UNITED STATES PATENT AND TRADEMARK OFFICE

APPLICATION NO.	FILING DATE	FIRST NAMED INVENTOR	ATTORNEY DOCKET NO.	CONFIRMATION NO.
10/691,854	10/23/2003	Mark H. Falahee	FLH-10702/29	6727
25006	7590	11/21/2006	EXAMINER	
GIFFORD, KRASS, GROH, SPRINKLE & CITKOWSKI, P.C PO BOX 7021 TROY, MI 48007-7021			PREBILIC, PAUL B	
			ART UNIT	PAPER NUMBER
			3738

Office Action Summary

Drawings

Fig - 1

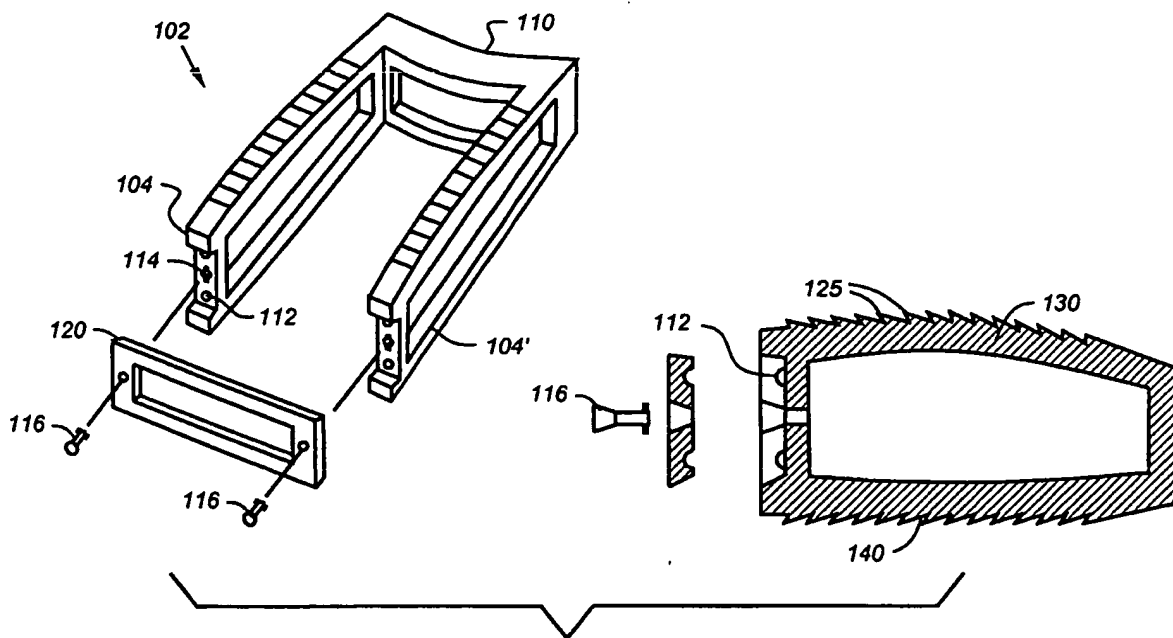
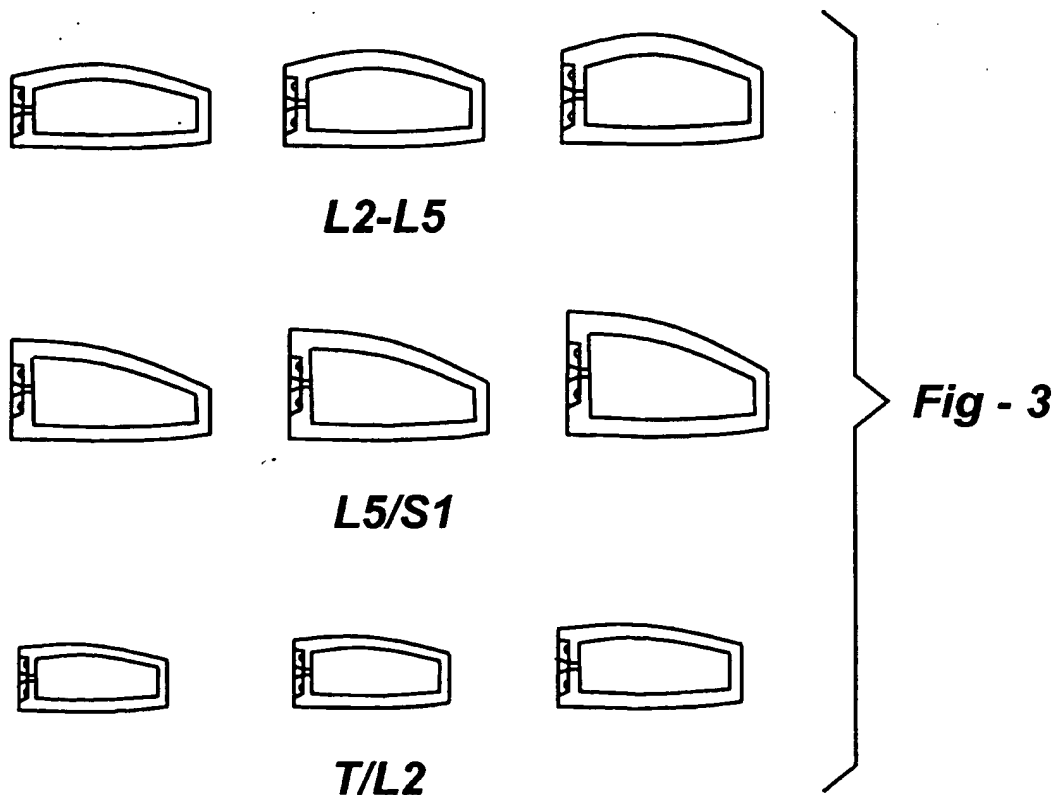
The drawings are objected to because Figures 1, 2, 3, 7C, 8A, 9A, and 9B have multiple components without projection lines of separate figure numbers; see 37 CFR 1.84 (u) (1) that is incorporated herein by reference. In addition, Figure 2 has some elements not identified with reference numbers such as the bottommost element of Figure 2. Corrected drawing sheets in compliance with 37 CFR 1.121(d) are required in reply to the Office action to avoid abandonment of the application. Any amended replacement drawing sheet should include all of the figures appearing on the immediate prior version of the sheet, even if only one figure is being amended. The figure or figure number of an amended drawing should not be labeled as "amended." If a drawing figure is to be canceled, the appropriate figure must be removed from the replacement sheet, and where necessary, the remaining figures must be renumbered and appropriate changes made to the brief description of the several views of the drawings for consistency. Additional replacement sheets may be necessary to show the renumbering of the remaining figures. Each drawing sheet submitted after the filing date of an application must be labeled in the top margin as either "Replacement Sheet" or "New Sheet" pursuant to 37 CFR 1.121(d). If the changes are not accepted by the examiner, the applicant will be notified and informed of any required corrective action in the next Office action. The objection to the drawings will not be held in abeyance.

Not
Approved
for
Entry
PBP
11/11/06

Fig - 2

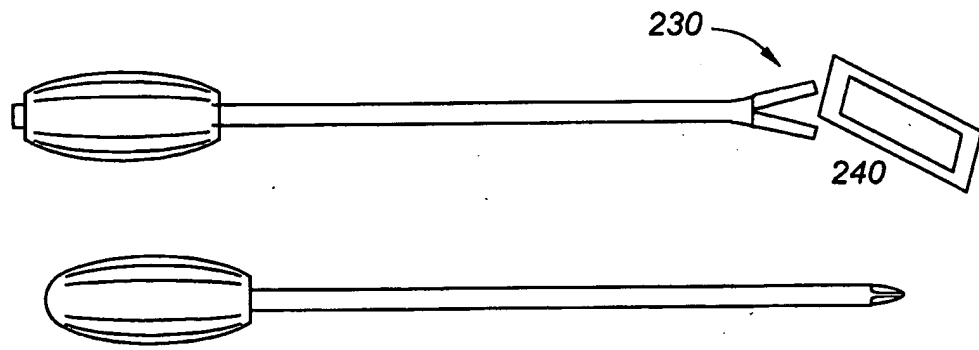
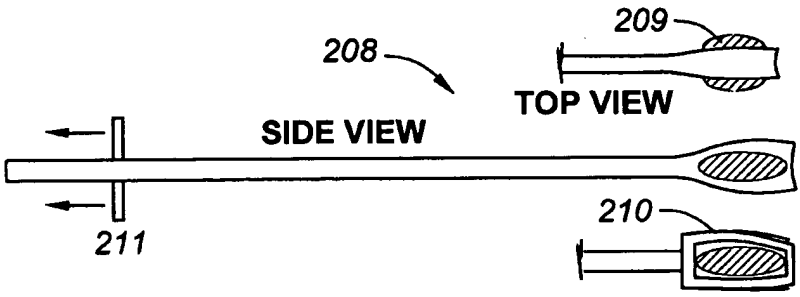
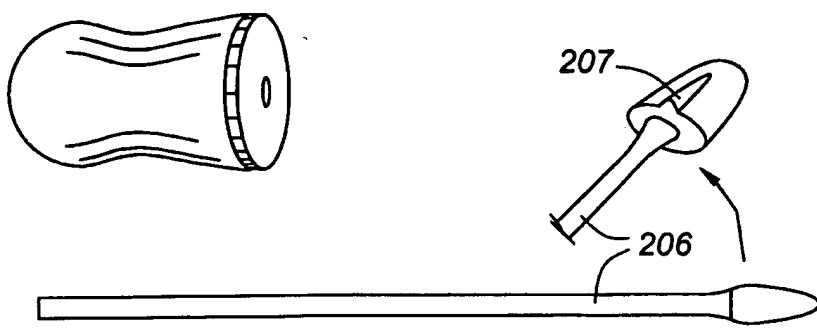
Not
Approved
For
Entry
PBP
11/11/06
